# **ADDENDUM NO. 1**

## **SUMMIT STREET PARK FALLON SCHOOL PLAYGROUND BID #16-055**

ISSUED: January 20, 2017

**ADDENDUM NO. 1  
 FALLON SCHOOL:  
 ALTERNATE SITE LAYOUT PLAN**

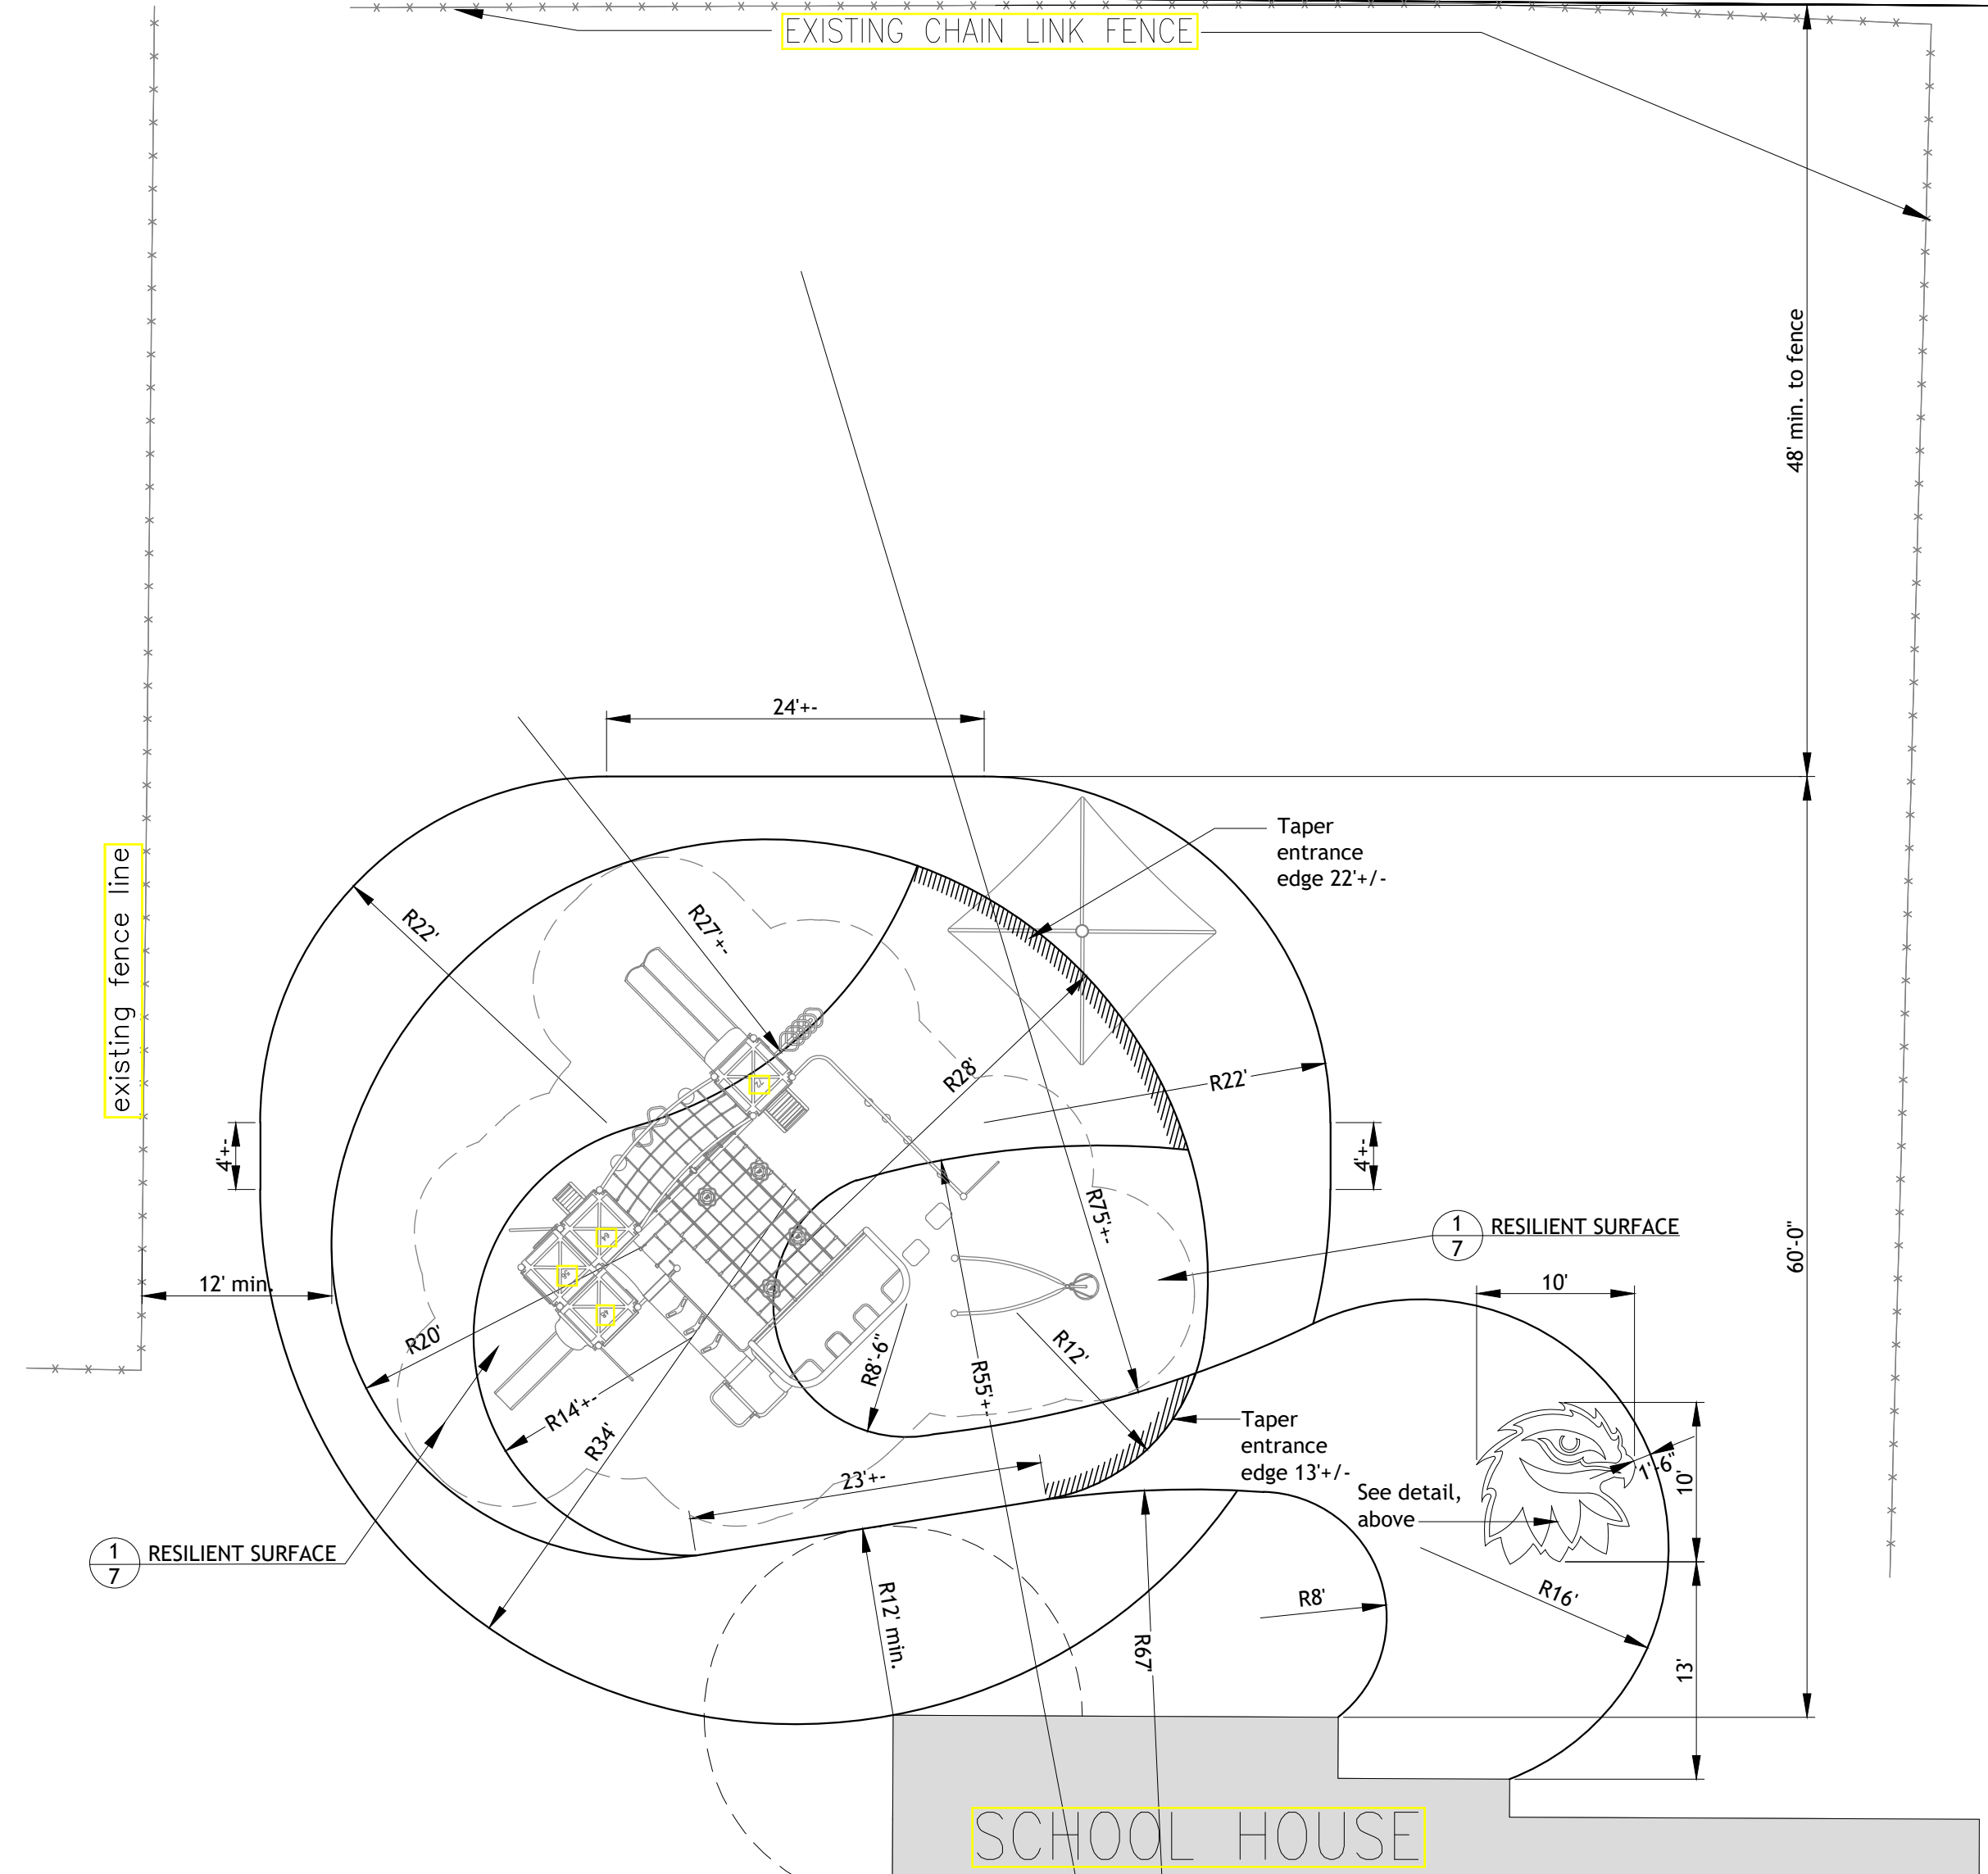
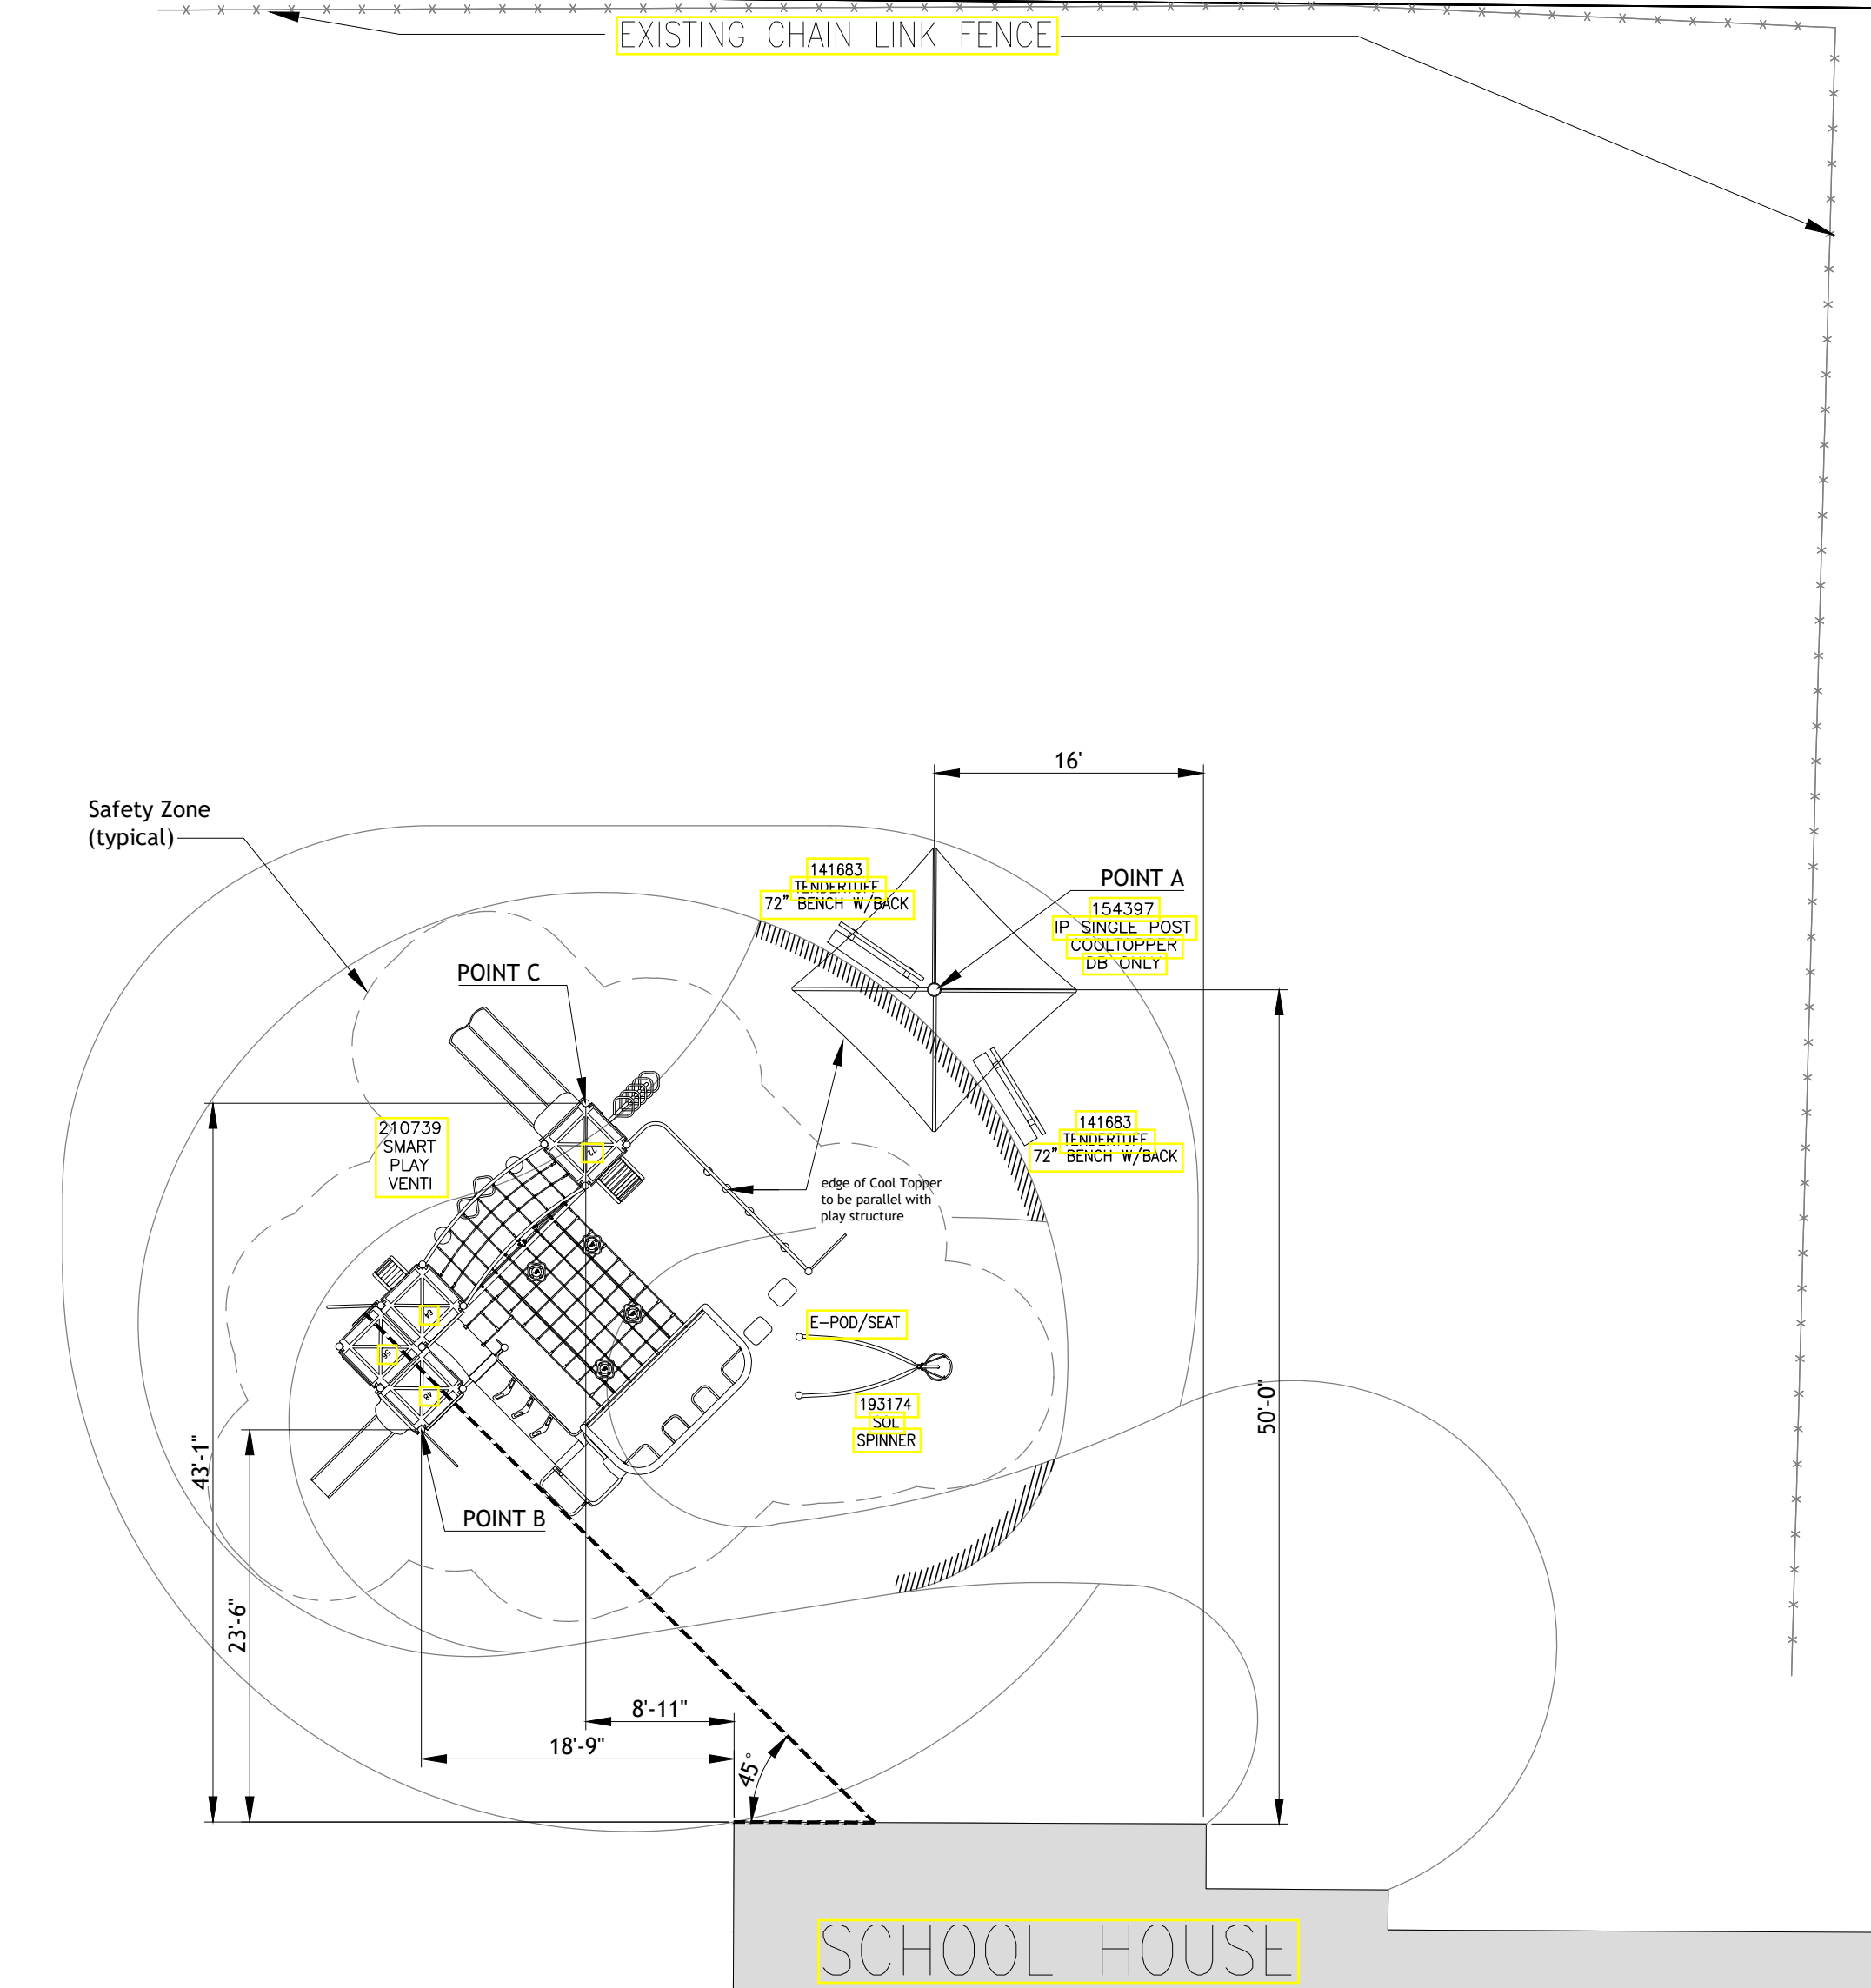
c. An Alternate Layout Plan has been issued with this Addendum (Sheet 7A). This is an alternate, and does not replace Sheet 7.

- a. New Bid Form. This replaces the Bid Form issued in the original RFP.
- b. New Specification Section 02760 - Site Furnishings & Structures. This replaces the Section 02760 issued in the original RFP.
- c. Additional Sheet 7A. This is an addition to the Plan Set. It allows the City to have a new playground placement, should it be needed at the time of contract award. Sheet 7A does not replace Sheet 7.

Alternate No. 5: DELETE Playground Placement and colored surfacing (Nova or equal) as Specified on Sheet 7. ADD Playground Placement and colored surfacing (Nova or equal) as Specified on Sheet 7A:
